**Response to Comments
on
EPA Draft 2020 Permit Modification to the 2016 Reissued RCRA Permit and
Associated Statement of Basis for EPA’s Remedial Action for the “Rest of River”
Portion of the Housatonic River**

GE-Pittsfield/Housatonic River Site

December 2020

U.S. Environmental Protection Agency
Region 1 (EPA New England)

**FIGURE 1
UPLAND DISPOSAL FACILITY,
SITE LOCATION MAP**

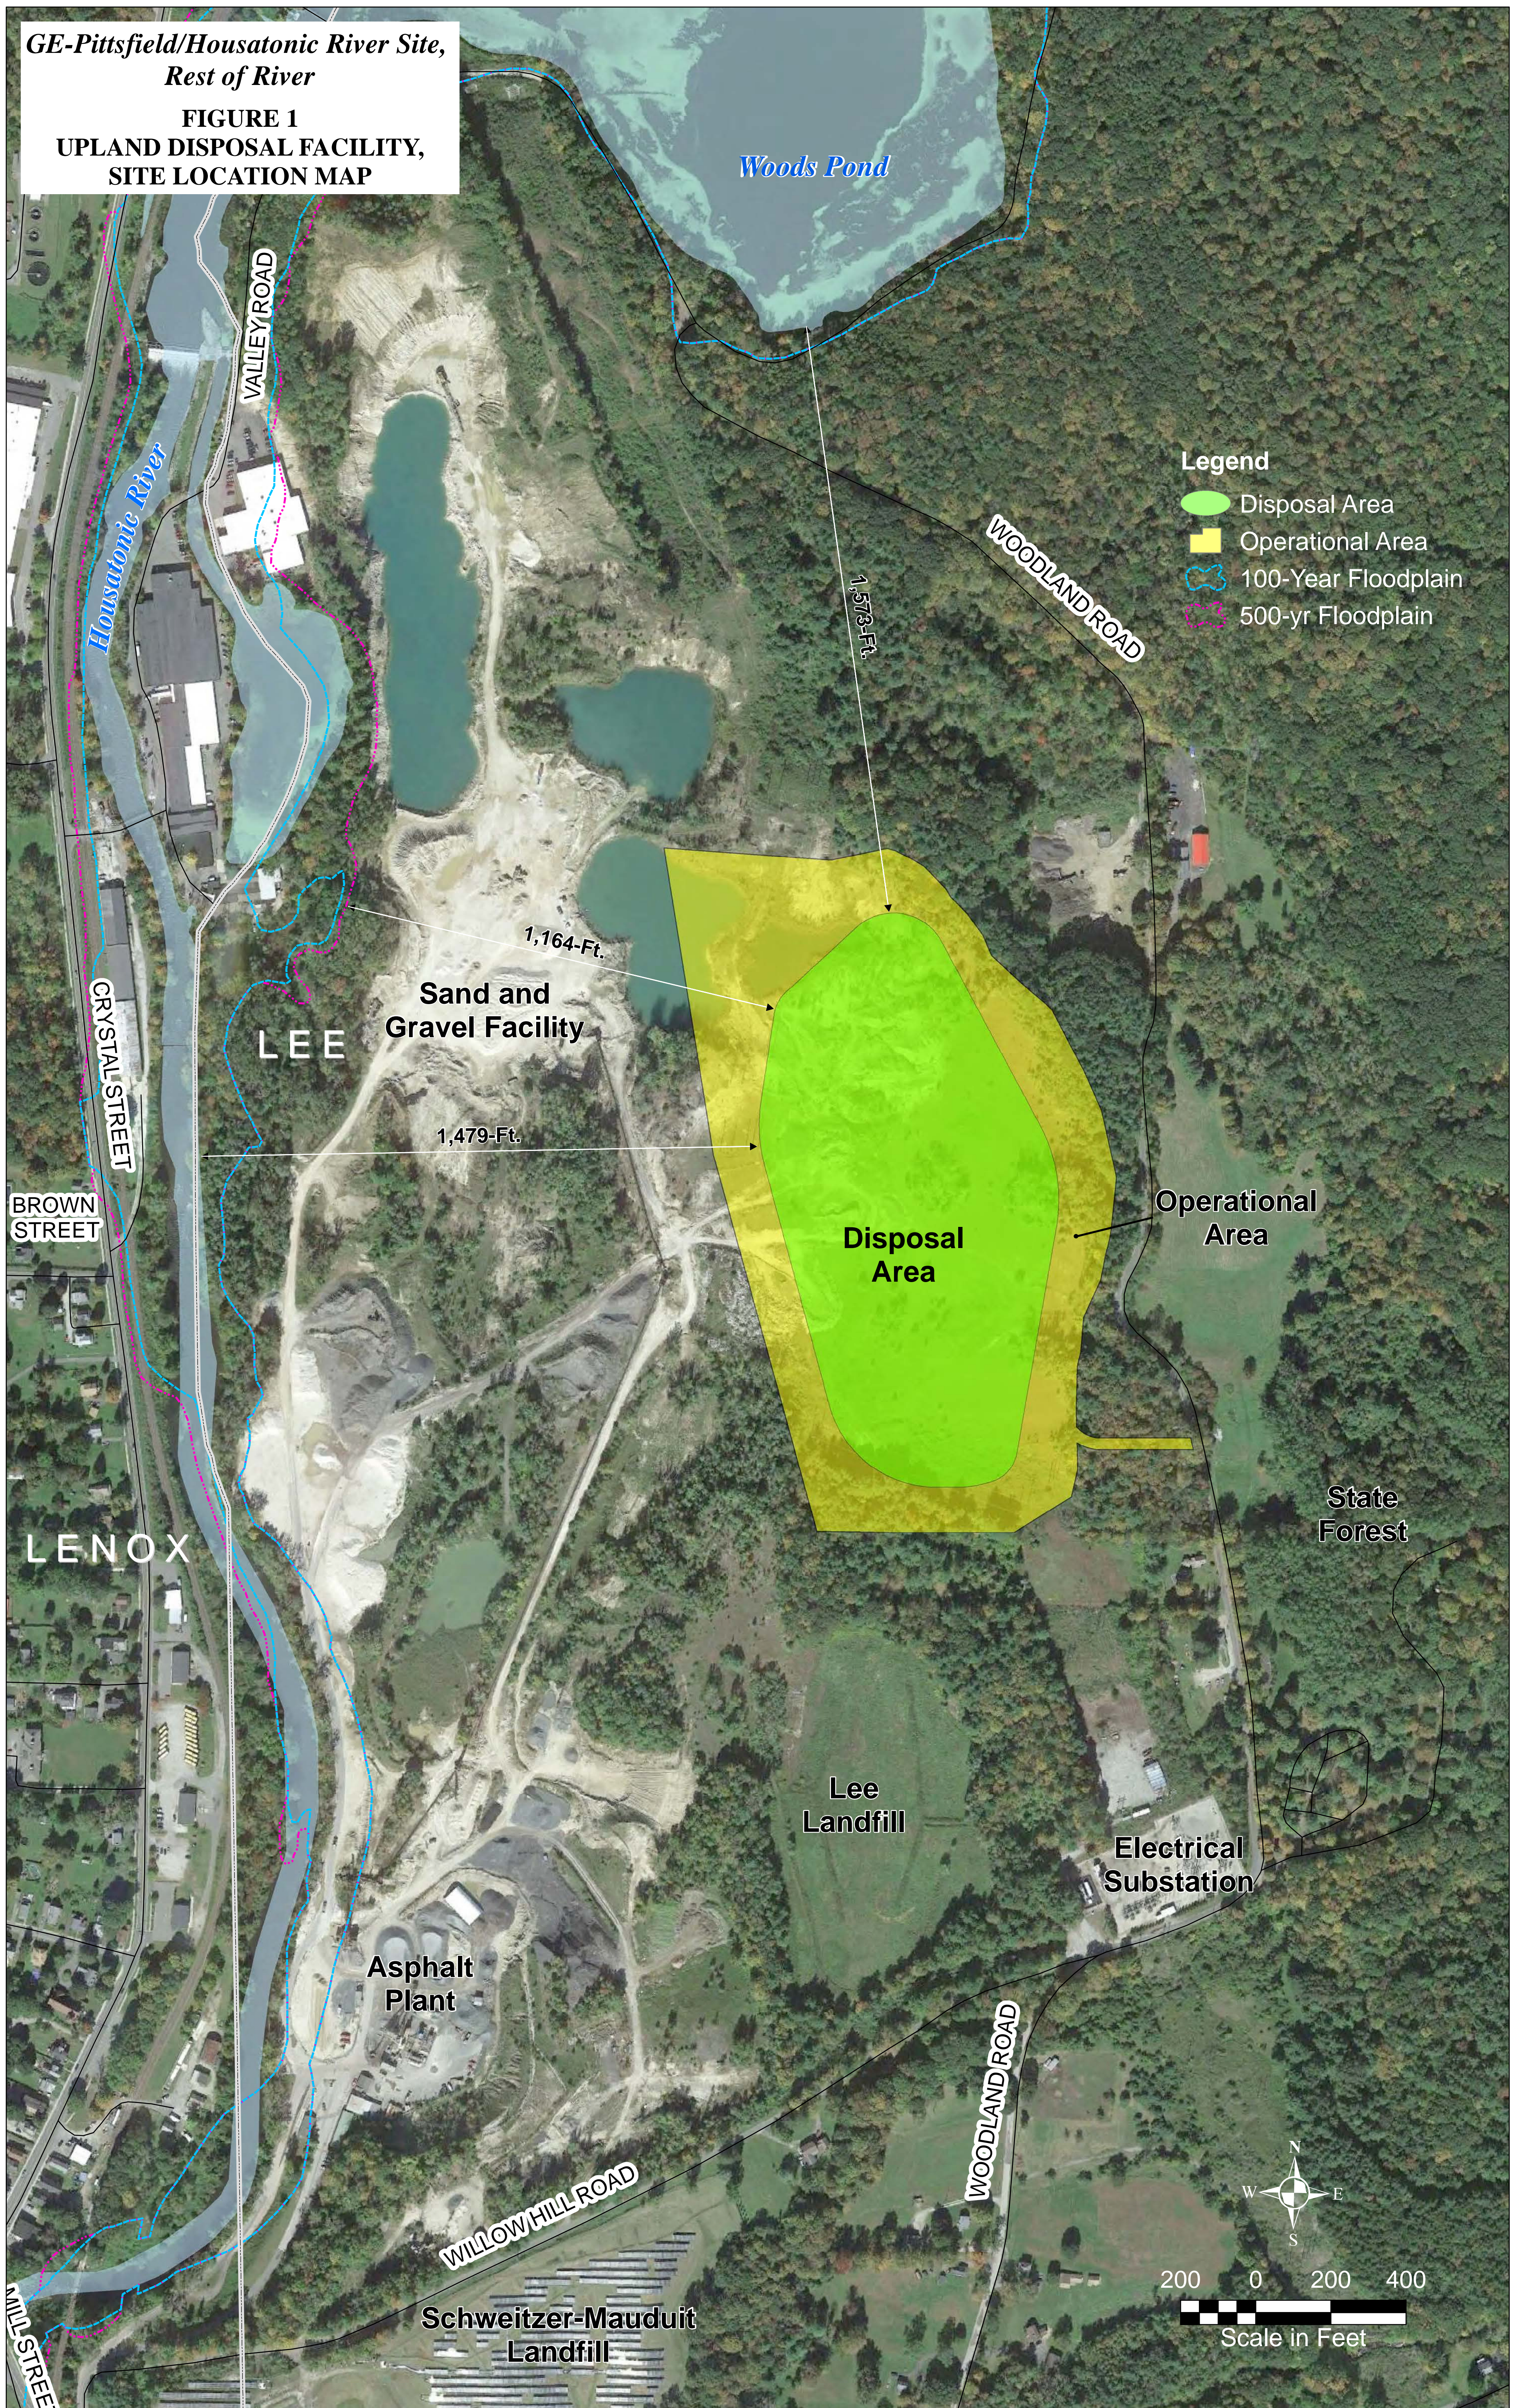
Comment II.A.1: Several commenters expressed strong opposition to the proposed UDF location. Specific comments in this category cited the consistent vehement community opposition to local disposal; air emissions and risks to the community during and after construction; concerns about frost effects, seismic activities/earthquakes, or extreme weather events on the UDF; the suitability of soils at the location for a landfill and contamination of groundwater; and the potential for re-contamination of the River from a failure or leaking of the landfill.

description of the UDF location to mean that wastes were being piled along a steep bank along the River. To the contrary, the UDF location is over a ¼-mile from the River and is well outside the 500-year floodplain (which is located 1,164 feet from the disposal area). Figure 1.

Regarding questions relative to the suitability of soils underlying the UDF location, it is first important to note that two other landfills already exist in this immediate area. Figures 1 and 2. Neither of those existing landfills have the benefit of a bottom liner, whereas the UDF will have a double bottom liner and leachate collection system. The UDF's liner system is protection against concerns regarding permeability of the underlying soils. For TSCA Chemical Waste Landfills, the regulations prescribe that a bottom liner be placed where underlying soils are permeable. 40 C.F.R. 761.75. The UDF will meet this requirement. Furthermore, state solid waste landfill regulations would allow the bottom of the landfill to be constructed to within 4 feet of the water table (310 CMR 16.40.3(a)(12)), whereas the Permit increases this buffer to no less than 15 feet. The underlying soil characteristics at this location have the added advantage of allowing the preparation of an ideal sub-base for proper grading, placement, and construction of the bottom double liner system. Permit, II.B.5.

- The proposed UDF is located in an industrial area that contains an asphalt plant, a sand and gravel pit, an electrical substation, and several commercial/industrial facilities and is near two closed landfills. The UDF is bordered to the north and east by a large state forest. Figure 1.

**FIGURE 2
SURFACE WATER PROTECTION ZONE A,
LEE PUBLIC WATER SUPPLY**

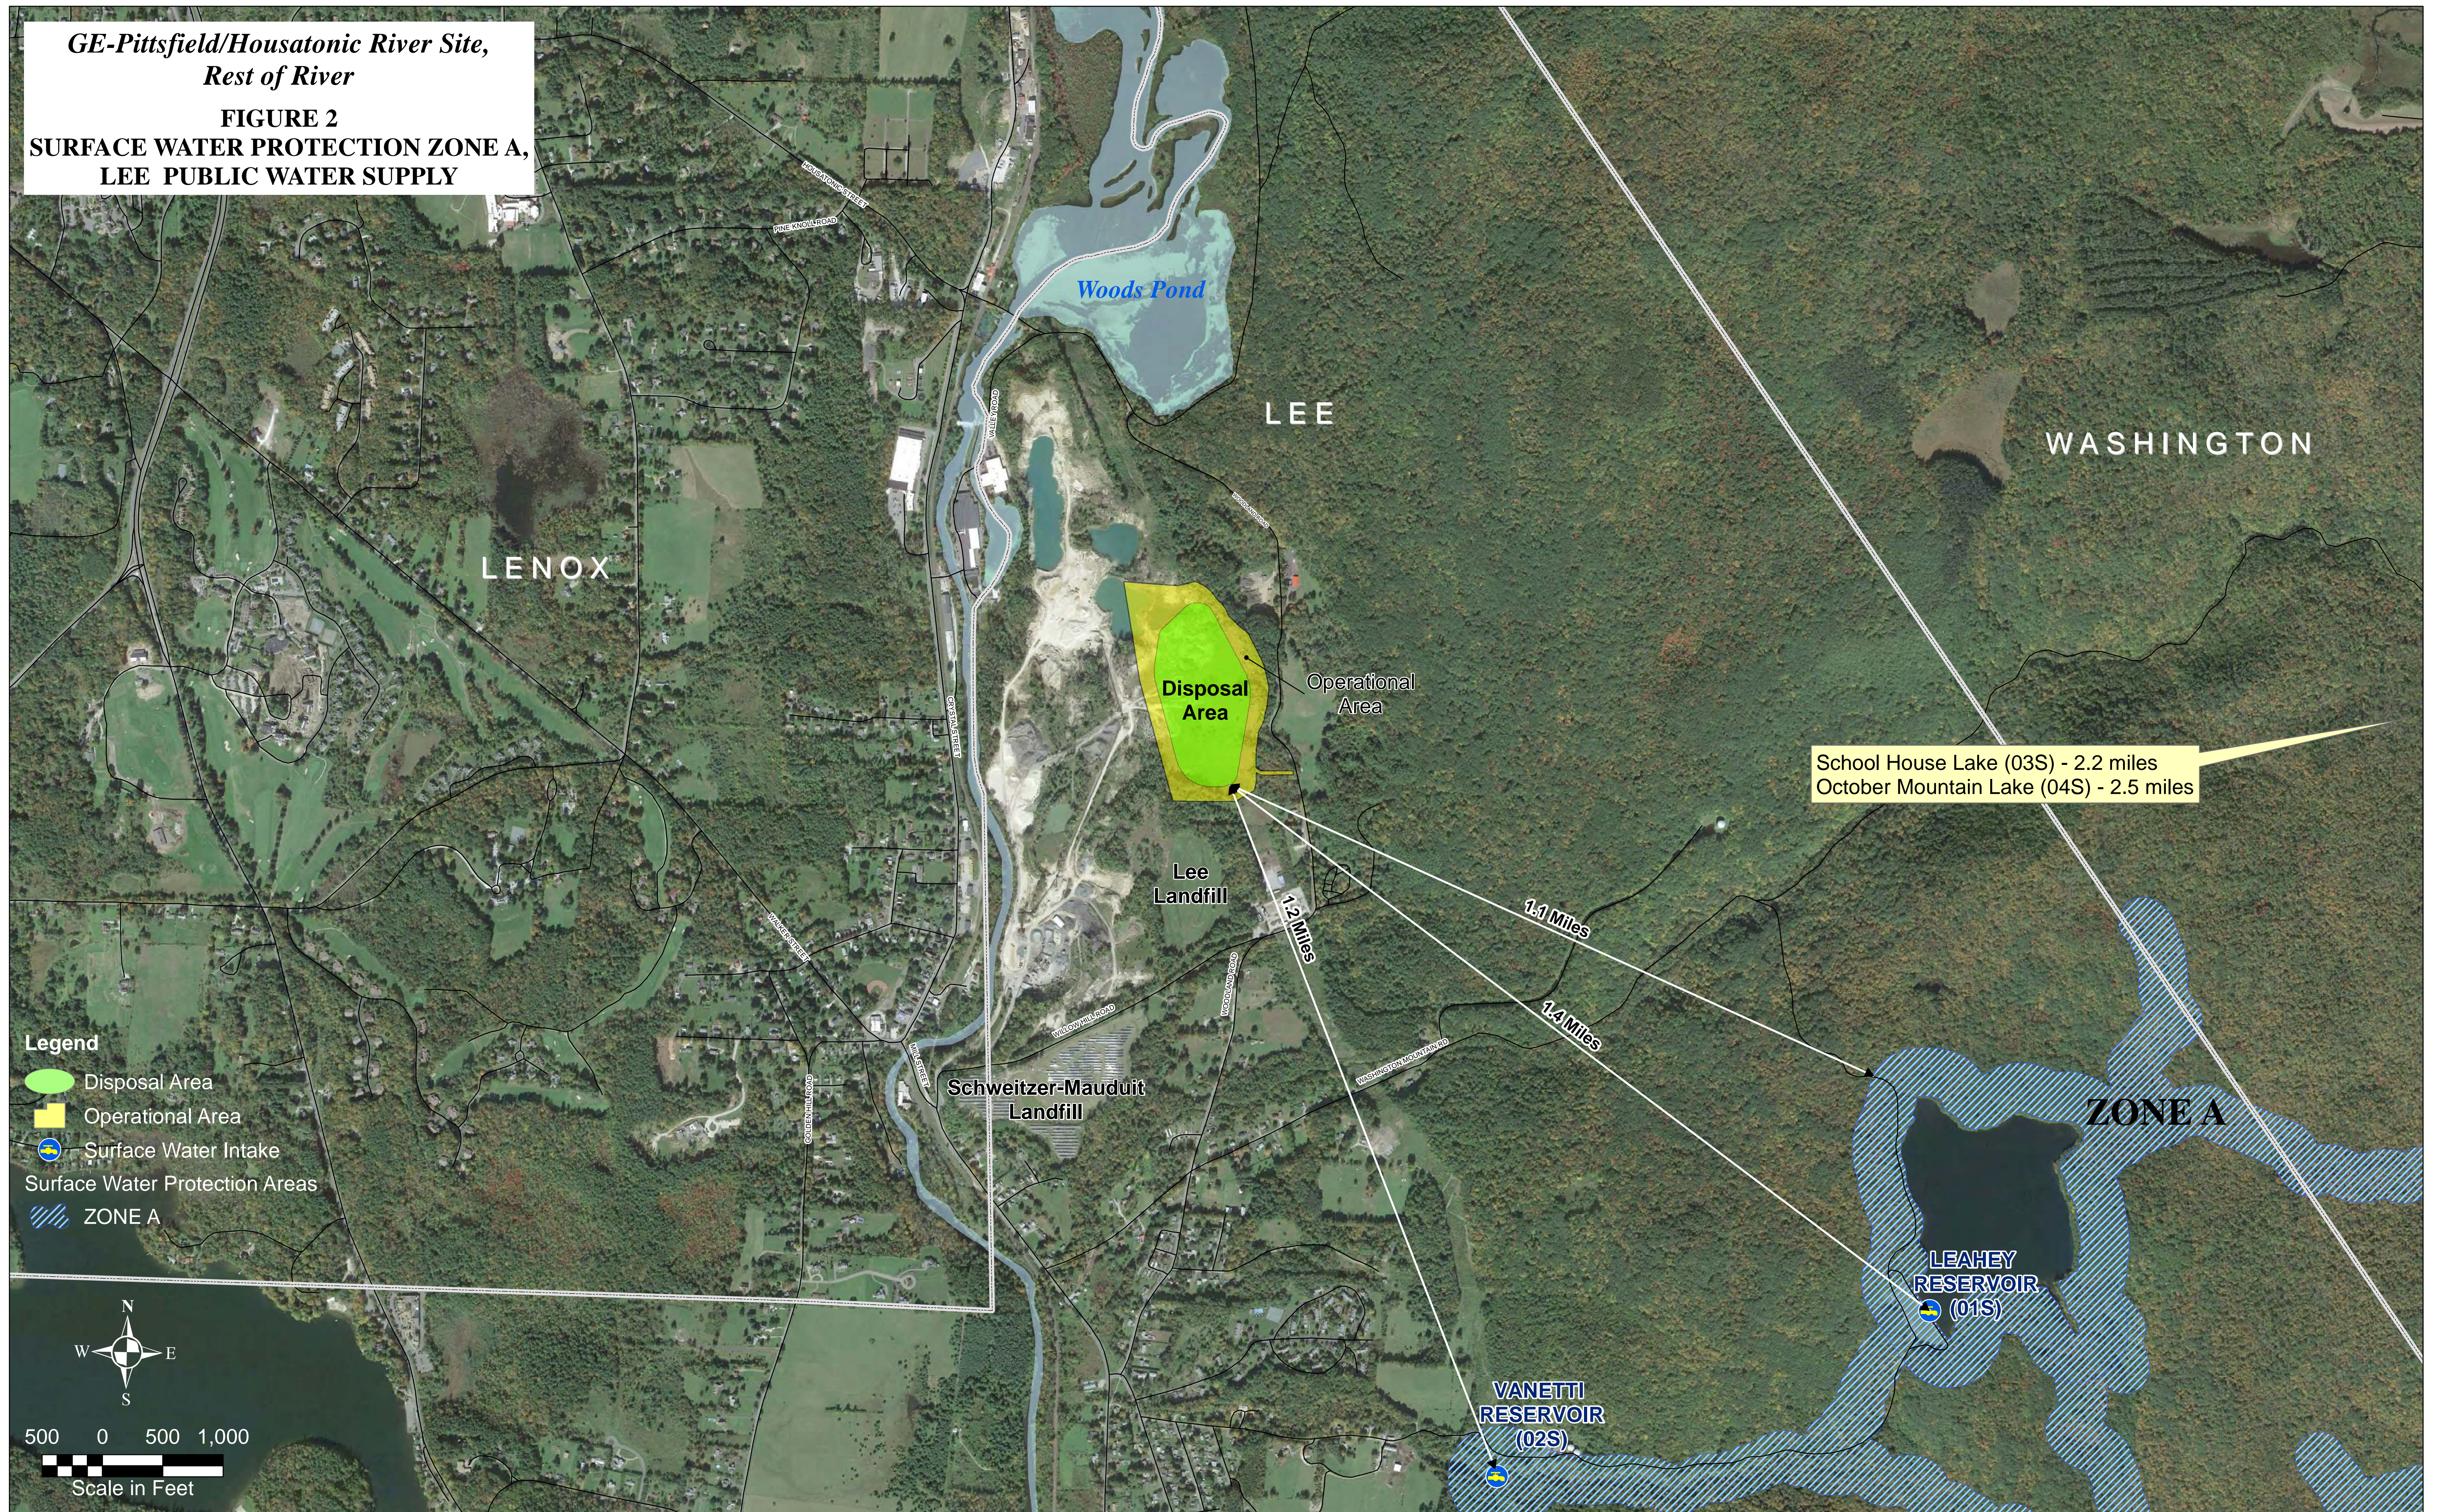
Comment II.A.5: Several commenters expressed concerns about impacts to local water supplies should a release occur. A number of commenters questioned the provisions for abandonment of

The UDF is also distant from drinking water protection zones. The Commonwealth of Massachusetts designates protection areas around all state water supplies to ensure that the water supplies are not affected by potential sources of contamination to the water supply. The following are the Surface Water Protection Zones that are used to provide increasing levels of protection:

GE-Pittsfield/Housatonic River Site,
Rest of River
FIGURE 3
OPCA AND ALLENDALE SCHOOL
PCB AIR MONITORING
LOCATIONS

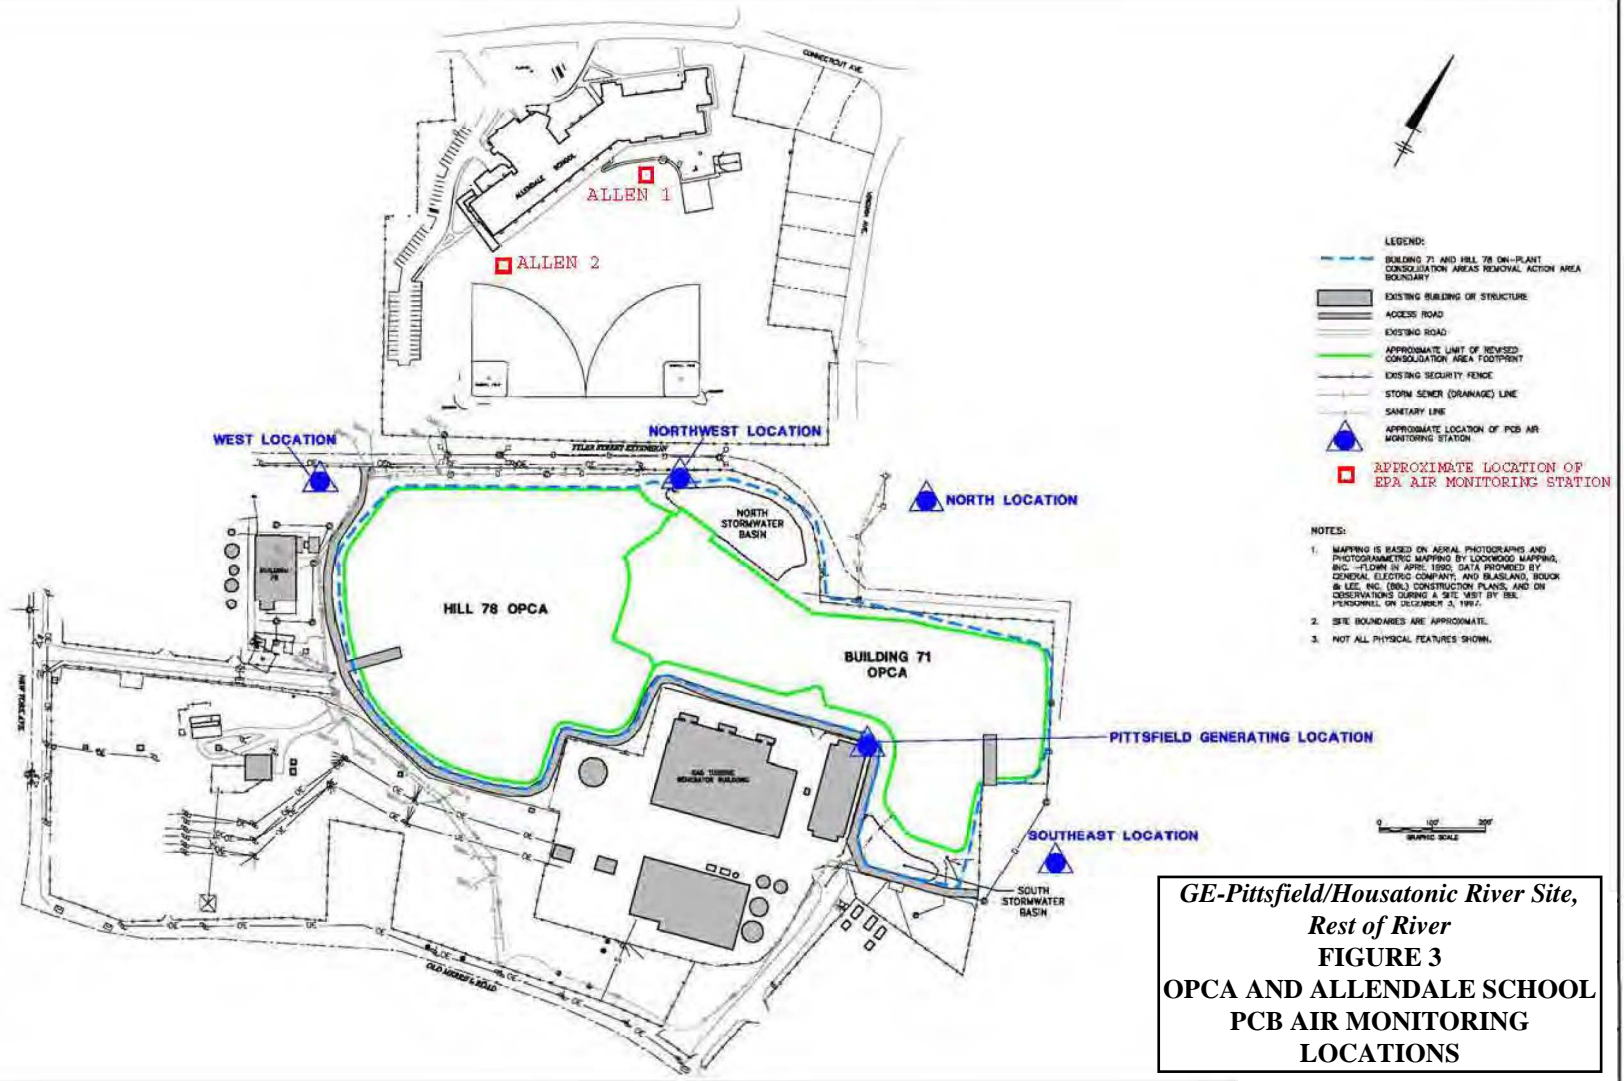
Comment II.A.3: Several commenters expressed concerns that the proposed UDF is similar to the landfills/OPCAs constructed in Pittsfield as part of the Consent Decree and that in the commenters' view, the landfills/OPCAs are leaking or are otherwise not safe.

At the onset of consolidation activities in 1999, EPA required that GE monitor the air surrounding the OPCAs at five air monitoring stations. Figure 3 presents the current OPCA air monitoring locations. These locations are on GE property and are all within a maximum of 250 feet of the OPCA disposal areas. In 1999, the Region set a site-specific notification level of a 24-hour average of 0.05 micrograms (μg) PCBs per cubic meter of air ($\mu\text{g}/\text{m}^3$) and an action level of $0.100 \mu\text{g}/\text{m}^3$. If a notification level was exceeded, GE was required to notify EPA as soon as practicable, but no later than 24 hours after receipt of the data showing such an
